STEERING JUDDER - S3 CARS

No. S3/N2

SIDE STEERING LEVER SETSCREWS - S3 CARS

ALTERNATIVE STEERING PUMPS

View of side steering lever showing the locking plate UR 8816
correctly tabbed

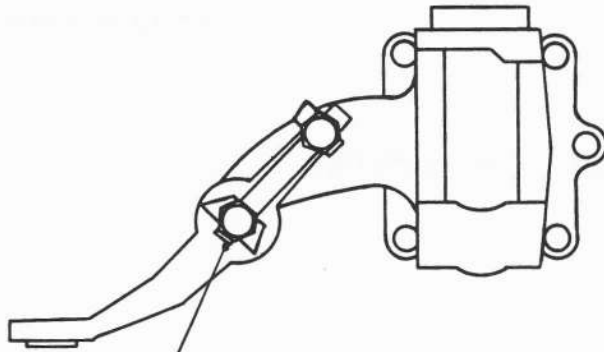
Carefully bend the locking tabs into position as shown. It is important that this operation is carried out with extreme care so as to ensure that each tab is flush against its hexagon flat, this condition being most essential for maximum effective locking.

NOTE: The waisted type of setscrew illustrated which was fitted to a few late series chassis has since been dispensed with. If encountered in service these setscrews should be removed and replaced by the non-waisted type UA 209/Z and UA 260/Z.

Secure each side steering lever into position using the new locking plate, tightening the original setscrews to their correct torque figure. It is of vital importance that when each setscrew is fitted the correct torque is applied to it. (Refer to torque figures listed). SEE NOTE.

Bend up one tab
for each setscrew

Tab to be flush
with hexagon flat

Figure 1. Fitting pump to swivel bracket

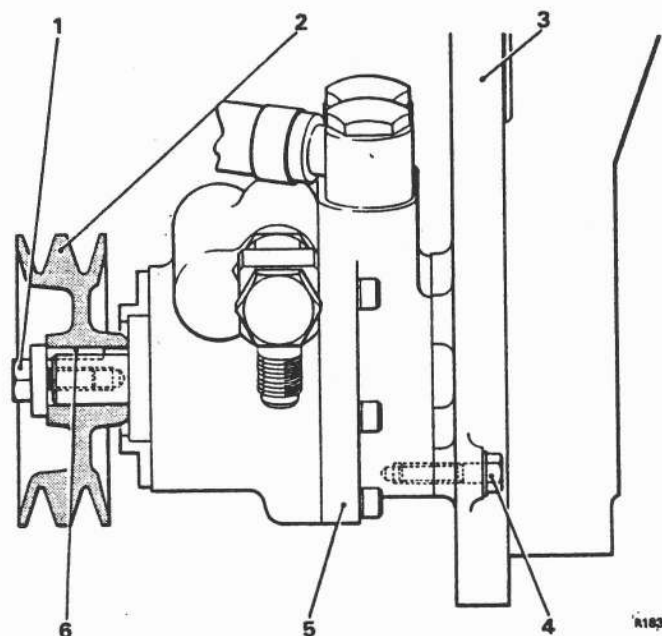
1. Disconnect the battery.
2. Unscrew the steering pump pulley retaining setscrew.
3. Remove the drive belts.
4. With a syringe, remove the fluid from the reservoir.

5. Disconnect the pump to steering box pressure pipe. Secure previously removed pipe vertically to prevent fluid loss; retain the banjo and sealing rings.
6. Remove the nuts and washers securing the pump swivel bracket to the 'B' bank cylinder head, detach the bracket and pump.
7. Remove the pump from the bracket and remove the pulley.
8. Mount the new pump (RH 8919) to the pump swivel bracket with four setscrews (UA 107/Z) and flat washers (UA 1251/Z)
9. Mount the pump swivel bracket to 'B' bank cylinder head.
10. Using Figure 1 for reference, fit the adapter (RH 8914), banjo (UE 30019), banjo bolt (UE 30020) and new sealing washers (UE 2514).

Figure 2. Pump in position

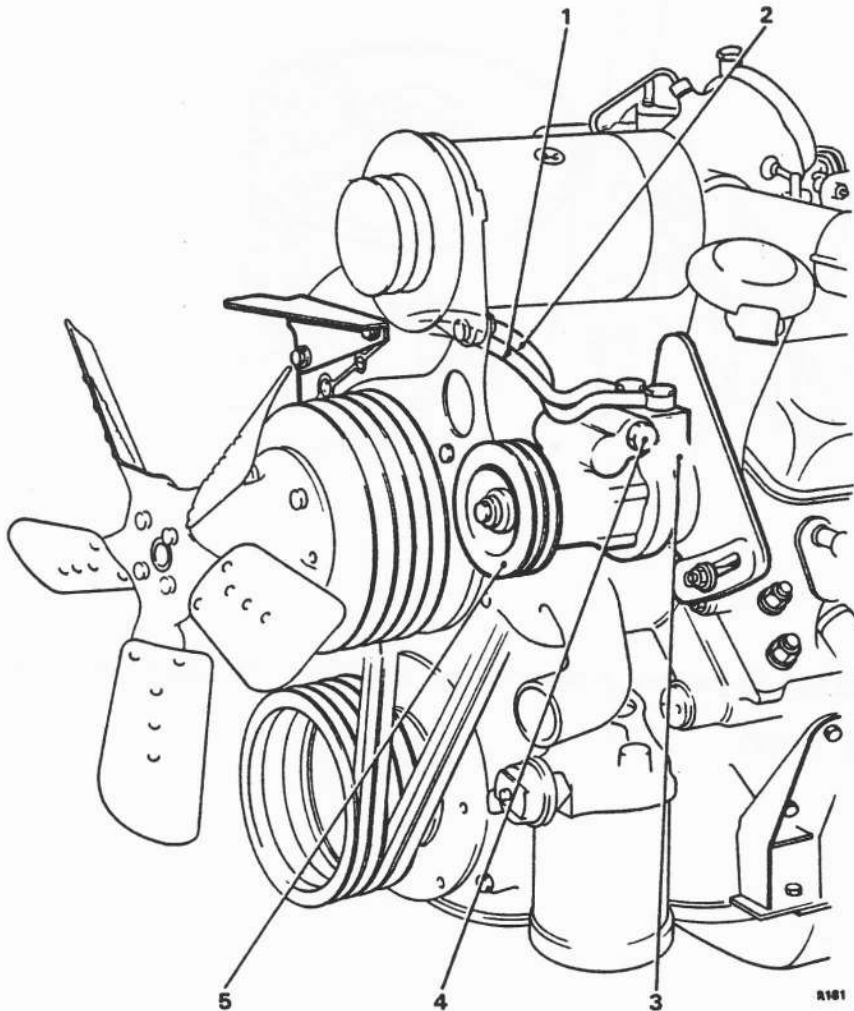
1. Using Figure 2 and Figure 3 as a guide, connect a hose, cut from RH 8912, between the pump and reservoir (pump return line).
2. Connect a hose cut from RH 8912, between steering box and reservoir (steering box return).
3. Connect a hose, cut from RH 8913, between the pump and reservoir.
4. The hoses should be clipped as shown.

1. The new pump swivel bracket (UE 9850) supplied, should be fitted in place of the existing bracket.
2. The steering box to reservoir return pipe should be disconnected, the steering box end banjo bolt retained, the hose discarded and a new hose, cut from PH 8912, fitted as Figure 2. The banjo bolt, with new seals, should be fitted with the new banjo (UE 30018) to the steering box.

Figure 3. Fitting reservoir mounting bracket RH 8920 to bulkhead.

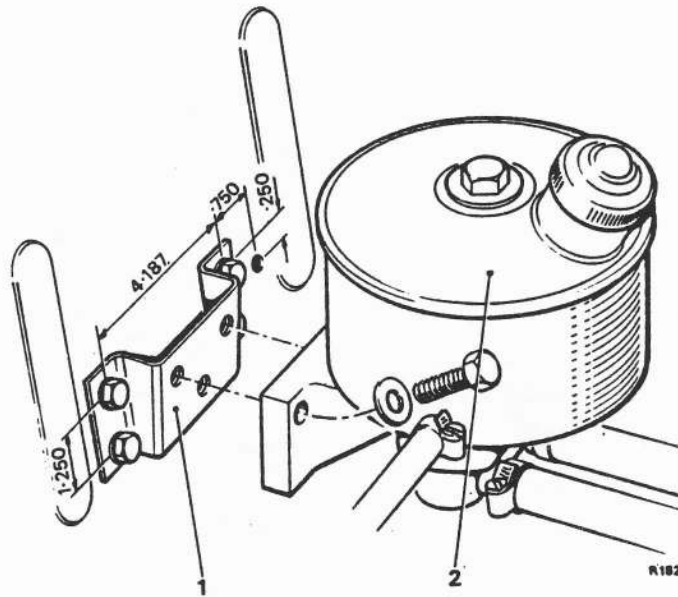
1. Using Figure 3 as a guide drill four holes into the bulkhead, insert an anchor nut (SPC 1697) into each hole, fit the reservoir bracket (RH 8920) and secure with the four setscrews (UA 103/Z) and washers (UA 1251/Z).

2. Mount the reservoir to the bracket with the three setscrews (UA 105/Z) and washers (UA 1251/Z).
